Access Compliance Report

Public Rights-of-Way

(Curb Ramps)

Intersection ID: 48018	Main Street: ROYAL_CASTLE_CT	Cross Street: TULLY_HOUSE_CT	Location: S
ADA ID: B4E484870716	Ramp Type: Perp	Initial Pass/Fail: Pass	Overall Compliance: No
			Severity Score: 10.25

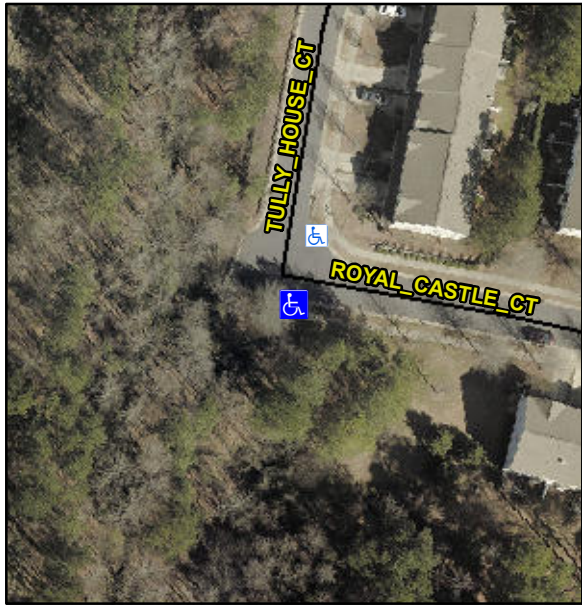
Codes/Mitigation Info/Possible Solution			Field Measurements/Component Compliance					
	Possible Solutions:		Compliance	Description	Data	Compliance	Description	Data
	Remove & Replace Entire Ramp.		N/A	Ramp Length (in)	48.0	Yes	Ramp Slope (%)	6.5
			Yes	Ramp Width (in)	48.0	No	Ramp XSlope (%)	4.3
			N/A	Flare Type LT	Sloped	N/A	Flare Type RT	N/A
			N/A	Flare Slope LT (%)	6.5	Yes	Flare Slope RT (%)	0.2
			N/A	Flare Traversable LT?	Yes	N/A	Flare Traversable RT?	Yes
			Yes	Landing Length (in)	48.5	No	DWS Provided?	No
			Yes	Landing Width (in)	49.5	N/A	DWS Contrast?	No
			No	Landing Slope (%)	2.5	N/A	DWS Length (in)	N/A
			Yes	Landing X Slope (%)	2.2	N/A	DWS Full Width?	No
<p>Surveyor Notes:</p> <p>N/A</p> <p>PROW/ADA:</p> <p>Not Found, R304.5.3, R304.2.2-Perp, R304.3.2-Para, R305</p>			N/A	Landing Curb? (Y/N)	No	N/A	DWS Offset (in)	N/A
			N/A	Shared Landing?	No			
			Yes	Gutter Ponding?	No	Yes	Gutter Slope (%)	1.7

Yes	Gutter Lip Ht (in)	0.0	Yes	Gutter X Slope (%)	1.7
			N/A	Painted X Walk1?	No	N/A	Painted X Walk2?	N/A
				X Walk 1 Direction	To NE		X Walk 2 Direction	N/A
			N/A	X Walk 1 Width (in)	N/A	N/A	X Walk 2 Width (in)	N/A
				X Walk 1 Slope (%)	1.4		X Walk 2 Slope (%)	N/A
				X Walk 1 X Slope (%)	2.8		X Walk 2 X Slope (%)	N/A
			N/A	Ramp inside XWalk1?	N/A	N/A	Ramp inside XWalk2?	N/A
Street 1 Name		ROYAL CASTLE CT		Road Slope (%)	N/A	N/A	Clear Space?	Yes
Stop Condition-Street 2		None		Road X Slope (%)	N/A	N/A	Clear Space to XWalk (in)	N/A
Street 2 Name		N/A	Yes	Any Obstructions?	No	Yes	Storm Grate/Utility Hazard?	No
Stop Condition-Street 1		N/A		Obstruction Type			Storm Grate/Utility Type	
Total Cost:		\$ 1850.00			N/A			N/A
						Yes	Surface Condition? (G/P)	Good
